Re: **PETITION NO. 1120** - The United Illuminating Company Petition for a Declaratory Ruling that No Certificate of Environmental Compatibility and Public Need is Required for the Modifications to the Hawthorne Substation Located at 180 Hawthorne Drive, Fairfield, Connecticut.

Please find enclosed the original and fifteen (15) copies of The United Illuminating Company's ("UI") responses to the Siting Council's First Set of interrogatories, dated December 16 and December 18, 2014 in connection with the above-referenced Petition. Additionally, UI will electronically file all responses and attachments via [siting.council@ct.gov](mailto:siting.council@ct.gov).

**Hawthorne Capacitor Bank Addition Project**

## WETLAND DELINEATION

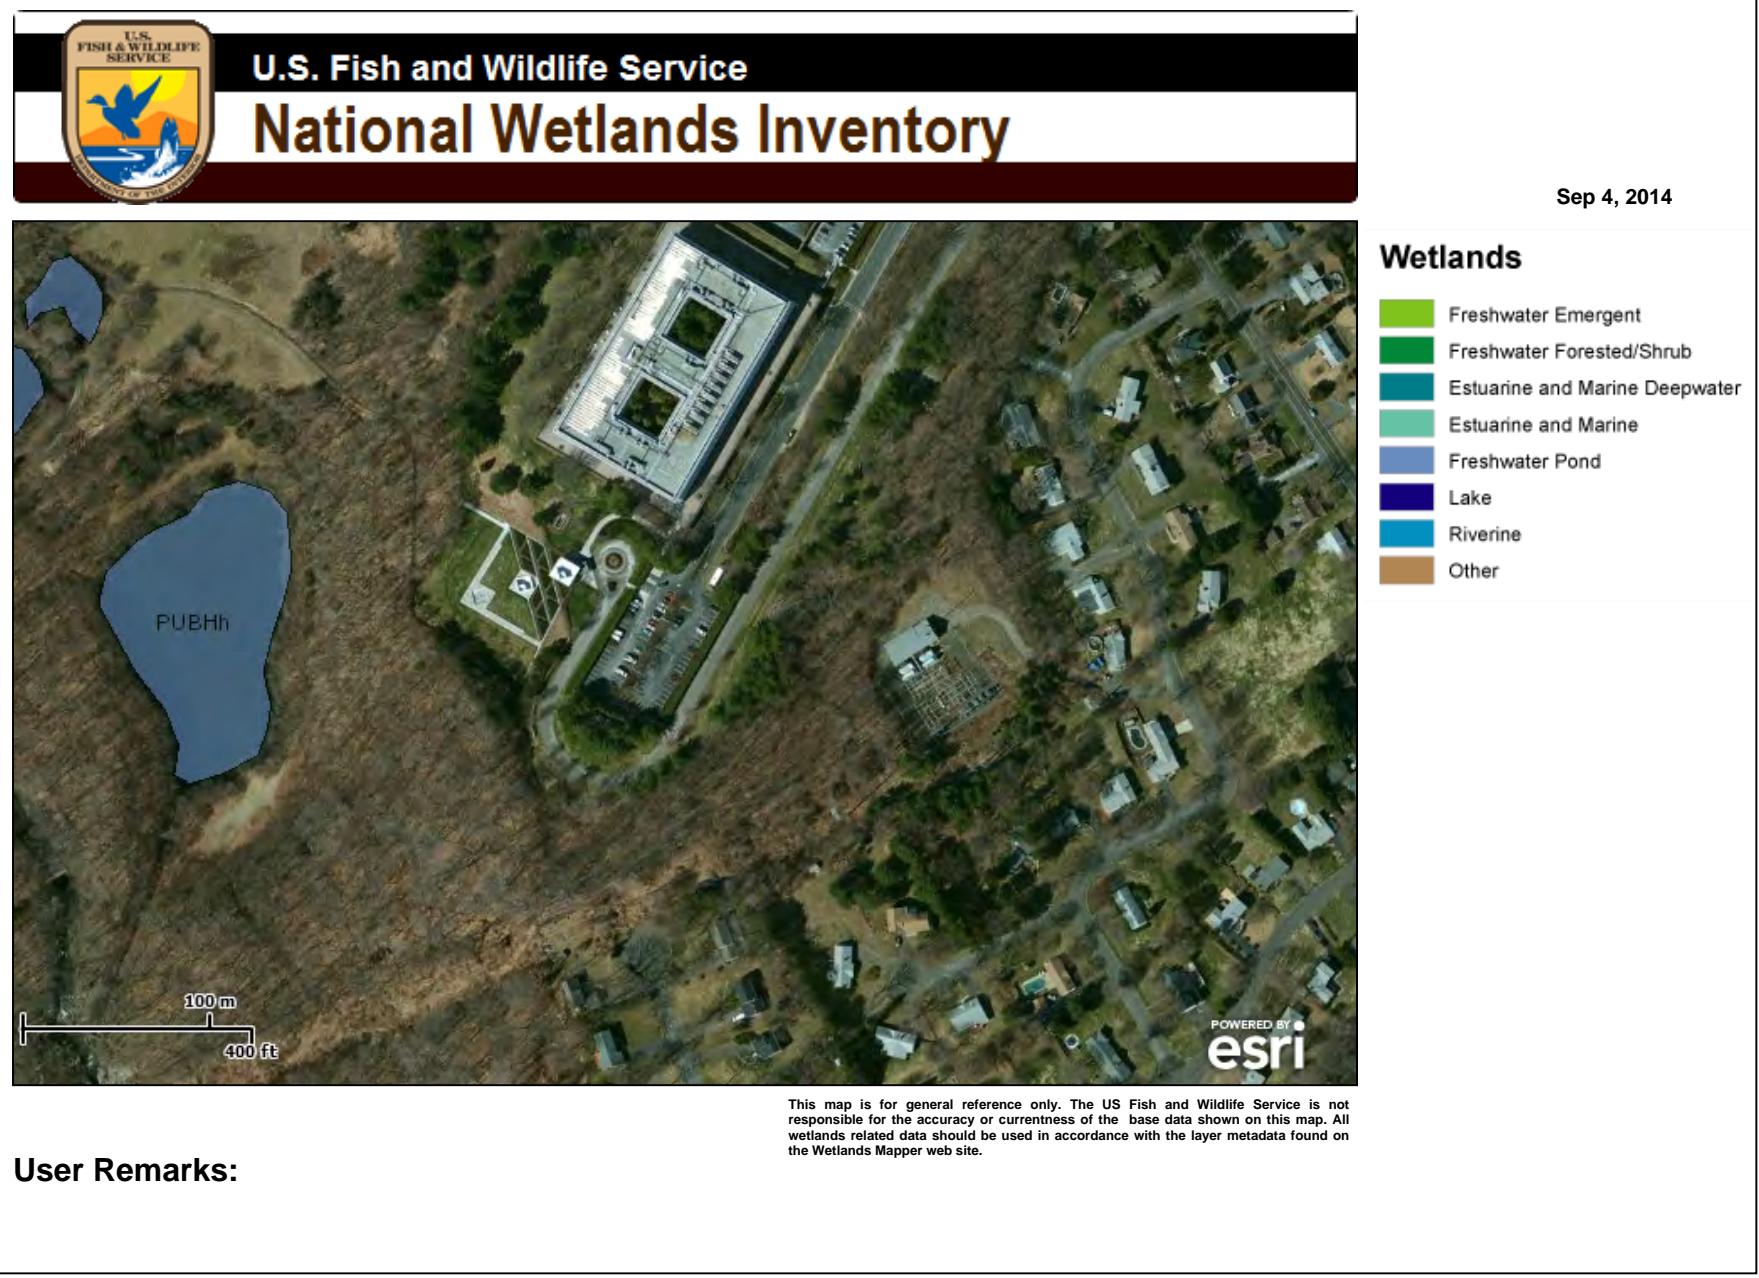
**CSC-004 Q:** Was a wetland survey conducted for the project? If so, please submit. If not, why not?

**CSC-004 A:** Yes a wetlands survey was performed on 9/5/2014. *Refer attachment A, Wetland Identification and Delineation Report.*

SITE  
PLAN

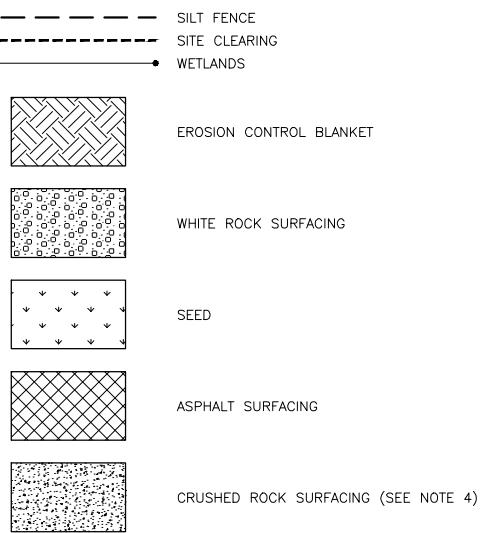
**CSC-006 Q:** Can evergreens for visual screening be installed along any portion of the proposed south fence line?

**CSC-008 Q:** Please submit a site plan for the project that depicts the following:

- a. Site clearing;
- b. Site grading;
- c. Distance to nearest wetlands;
- d. Distance to nearest residence;
- e. Fencing and component layout;
- f. Landscaping; and
- g. Drainage control features.

**CSC-006 A:** With the appropriate approvals from CL&P, UI can place screening shrubs along the southern fence line. The screening shrubs must have a maximum mature height of 15 feet. Rhododendrons are recommended as their maximum mature height meets the previously stated requirements and have some resistance to deer. If CL&P approves the placement of shrubs, UI reserves the right to trim the screening as needed to maintain the required clearances and security setback from the southern fence line. Screening would require the purchase and installation of infrared security cameras along the south fence line, due to the added security risk of low visibility, to provide 100% coverage of the perimeter. Current design includes standard video cameras for required security coverage. *Refer to attachment D, Site Plan.*

**CSC-008 A:** *Refer to attachment D, Site Plan.*
